# Cabarita Beach Mixed Use Development Modification 6

Cabarita Beach Mixed Use Development Modification 6  
Assessment Report  
State Significant Development Modification Assessment  
(MP 07\_0179 MOD 6)

February 2021

Published by the NSW Department of Planning, Industry and Environment

**Figure 4** Proposed Alteration to Level 1 - Courtyards previously known as the Landscape Podium

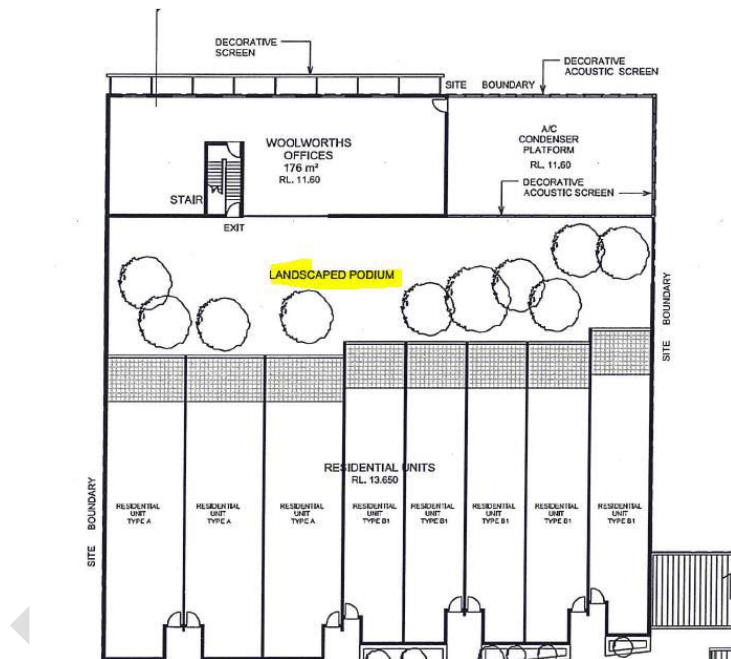
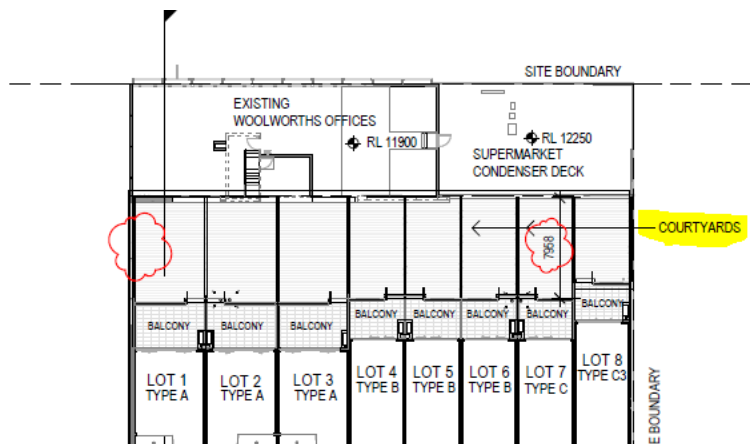
- Altering the Level 1 landscaped podium from inaccessible landscaped open space to private open space courtyards behind units 1-8.

- Relocation of the western bank of units towards Hastings Road to the west to improve the amenity of the units, specifically access to natural light and improved privacy.
- Allocation of the western landscape podium at level 1 to the respective units as demonstrated on the amended plans (identified as courtyards) to improve the overall amenity of the development.

Further, the landscape podium between Hastings Road and the western bank of units as approved is not accessible by any residents, and therefore a design change to this use is sought. The reallocation of this landscaped open space to private open space is considered to be a more practical use of the area, with no significant impacts on the development or the surrounding environment. The development is located across from Cabarita Beach and therefore has accessible public open space available for residents within the surrounding area.

Public and Council submissions raised concerns about the potential impact of the proposed reallocation of landscaped open space to private open space for units 1-8 referred to as 'courtyards' on the properties on Hastings Road. The key concerns are visual amenity, noise and privacy impacts.

Council did not support this reallocation as it represents a missed opportunity for public open space and limited detail was provided in relation to the visual impact of the revised proposal when viewed from street level of Hastings Road. Council noted that it may be more appropriate to allow individual access from units 1-8 as proposed, but to retain the area as a single landscaped area which allows for access for other unit occupiers.

The Applicant has provided additional plans detailing sightlines from the neighbouring properties on Hastings Road. The plans demonstrate neither the courtyards nor the units are visible from the opposing properties. As the courtyards are not visible from surrounding properties, the Department is satisfied that utilising this area as a landscape buffer for visual amenity purposes is of minimal advantage, as it would provide no benefit to adjoining properties. Similarly, landscaping this podium will provide no benefit to privacy as there are no significant impacts in this regard.

The Department is satisfied that this proposed reallocation of space is appropriate in this case, as the space is not being used to provide any benefits to surrounding properties and will not cause

significant noise, privacy or visual amenity impacts as the space is not visible from adjoining properties.
